MFN 06-265

Docket No. 52-010

**Subject: Response to Portion of NRC Request for Additional Information
Letter No. 26 Related to ESBWR Design Certification Application –
Isolation Condenser - RAI Numbers 5.4-22, 5.4-27, 5.4-31, 5.4-40, 5.4-43, 5.4-47, 5.4-49 and 5.4-51**

**Response to Portion of NRC Request for
Additional Information Letter No. 26
Related to ESBWR Design Certification Application
Isolation Condenser
RAI Numbers 5.4-22, 27, 31, 40, 43, 47, 49 and 51**

Figure 5.4-(to be assigned) Isolation Condenser System Simplified Process Diagram

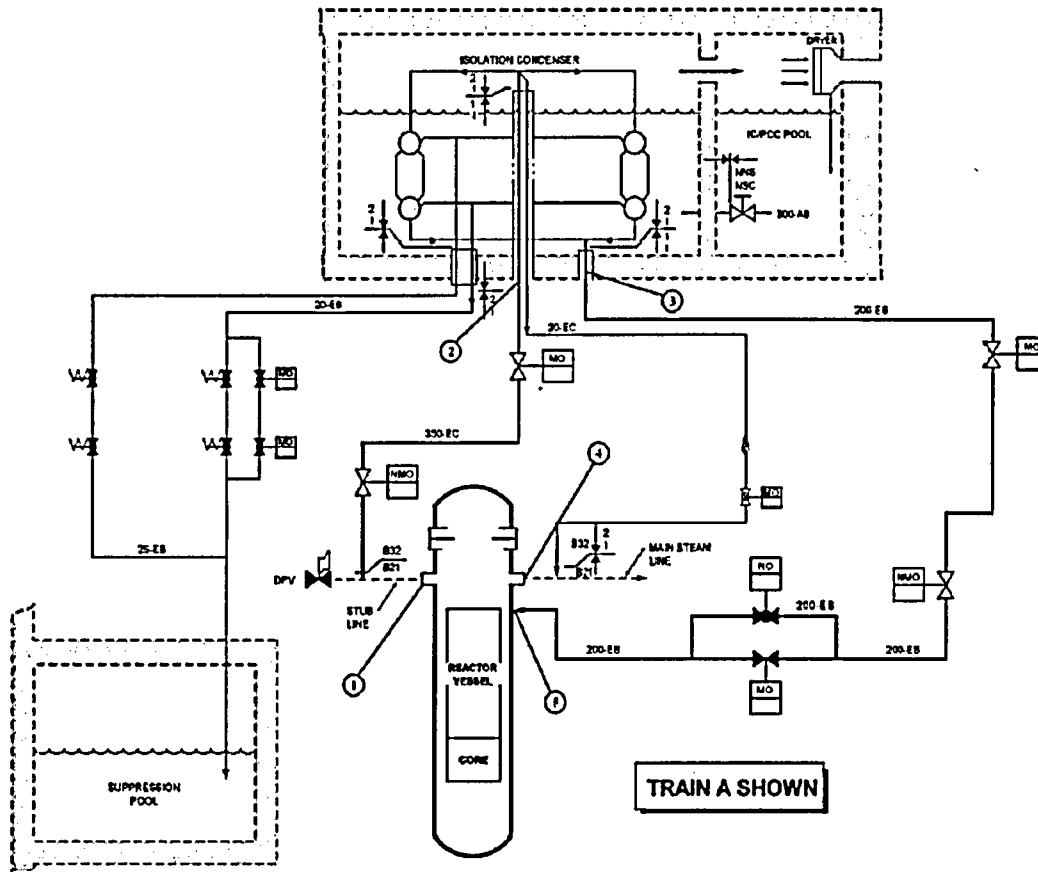
The staff finds the system operation parameters given in Table 5.4-1 is not complete. Provide a diagram showing the ICS design and operating parameters: pressures, temperatures and flow rates. The diagram should be similar to a GE standard Process Flow Diagram (PFD) for the ICS.

A simplified Isolation Condenser System (ICS) process flow diagram (PFD) is provided in the following figure. DCD Tier 2 Section 5.4 will be revised in the next update to incorporate this figure. The requested design data, associated with the figure, follows the figure.
